**TABLE OF CHANGES FOR PLANNING
AMMENDMENTS: SECTIONS & ELEVATIONS**

Project Title
T2 VITA LIVING, ST. JOHNS

Drawing Title
**PROPOSED CONTEXTUAL
WEST ELEVATION**

Drawing Number
6555-P-B500-E-W-001

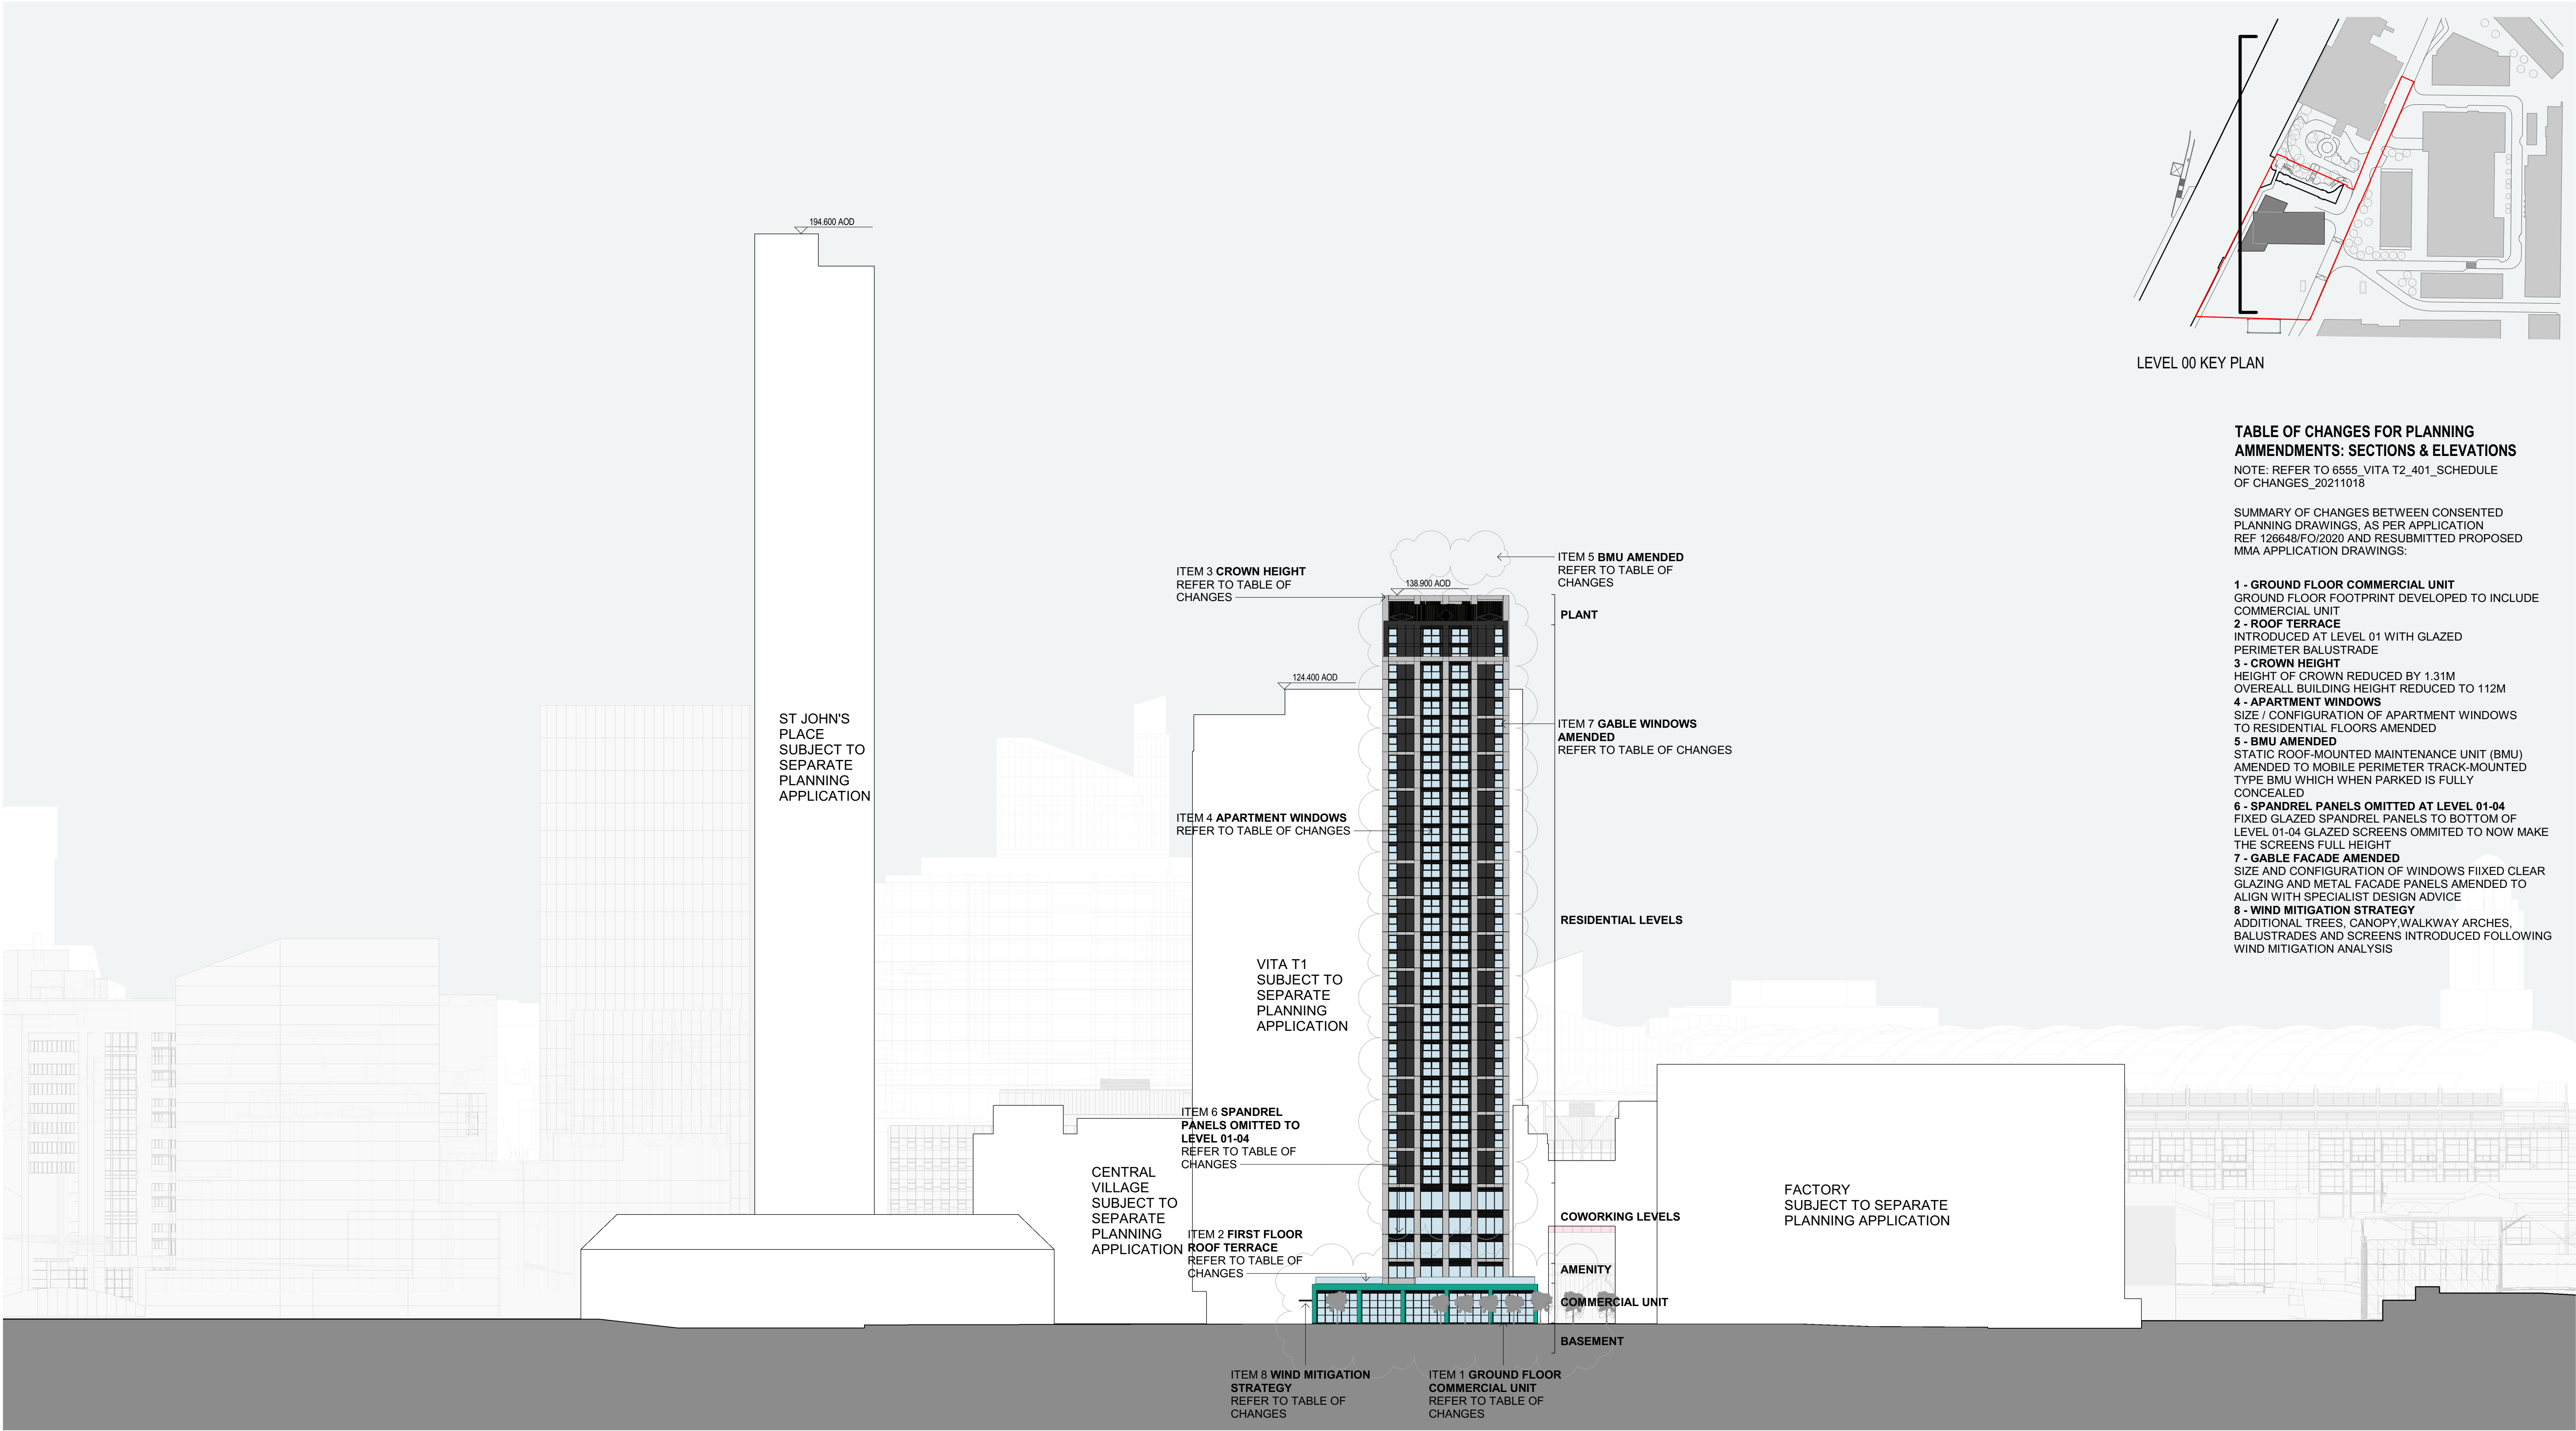
- 1 - GROUND FLOOR COMMERCIAL UNIT**
GROUND FLOOR FOOTPRINT DEVELOPED TO INCLUDE
COMMERCIAL UNIT
- 2 - ROOF TERRACE**
INTRODUCED AT LEVEL 01 WITH GLAZED
PERIMETER BALUSTRADE

- 3 - CROWN HEIGHT**
HEIGHT OF CROWN REDUCED BY 1.31M
OVEREALL BUILDING HEIGHT REDUCED TO 112M
- 4 - APARTMENT WINDOWS**
SIZE / CONFIGURATION OF APARTMENT WINDOWS
TO RESIDENTIAL FLOORS AMENDED

- 5 - BMU AMENDED**
STATIC ROOF-MOUNTED MAINTENANCE UNIT (BMU)
AMENDED TO MOBILE PERIMETER TRACK-MOUNTED
TYPE BMU WHICH WHEN PARKED IS FULLY
CONCEALED
- 6 - SPANDREL PANELS OMITTED AT LEVEL 01-04**
FIXED GLAZED SPANDREL PANELS TO BOTTOM OF
LEVEL 01-04 GLAZED SCREENS OMMITED TO NOW MAKE
THE SCREENS FULL HEIGHT

- 7 - GABLE FACADE AMENDED**
SIZE AND CONFIGURATION OF WINDOWS FIXED CLEAR
GLAZING AND METAL FACADE PANELS AMENDED TO
ALIGN WITH SPECIALIST DESIGN ADVICE
- 8 - WIND MITIGATION STRATEGY**
ADDITIONAL TREES, CANOPY, WALKWAY ARCHES,
BALUSTRADES AND SCREENS INTRODUCED FOLLOWING
WIND MITIGATION ANALYSIS
